Re: Cornelius Lacey PRD - Pre-Application

PREA23-036

RE: Cornelius and Lacey Property, File# PREA23-036

SUBJECT: PREA 23-036 - Cornelius Lacey PRD

STANDARD PLAN 3-201-003

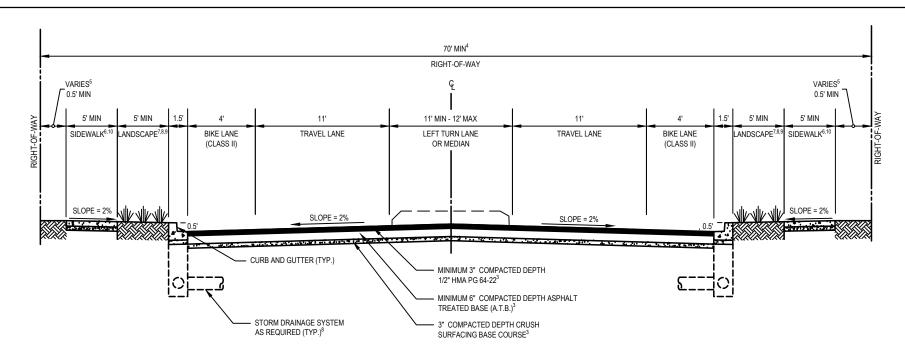
- a. 83<sup>rd</sup> Ave NE is classified as a minor arterial street and is to be built compliant with SP 3-201-003 of the EDDS and shall have a 6' sidewalk and 6' planter.

STANDARD PLAN 3-201-004

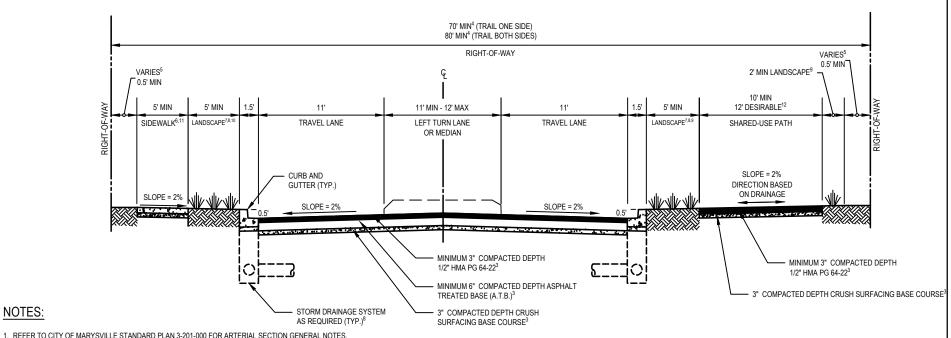
- b. 44<sup>th</sup> ST NE (Road A) is to be built as per SP 3-201-004 of the EDDS as a half street improvement.
  - c. No frontage improvements will be required along Sunnyside School Rd.

- a. 83rd Ave NE is designated as a Minor Arterial.
  - b. Roadway cross-section shall be 70' ROW three lane roadway with bike lanes per EDDS Standard Plan 3-201-004.

- a. Roadway cross-section shall be 70' ROW three lane roadway with bike lanes per EDDS Standard Plan 3-201-004.
    - i. Half street improvements shall be constructed with a minimum of 20' of asphalt pavement.
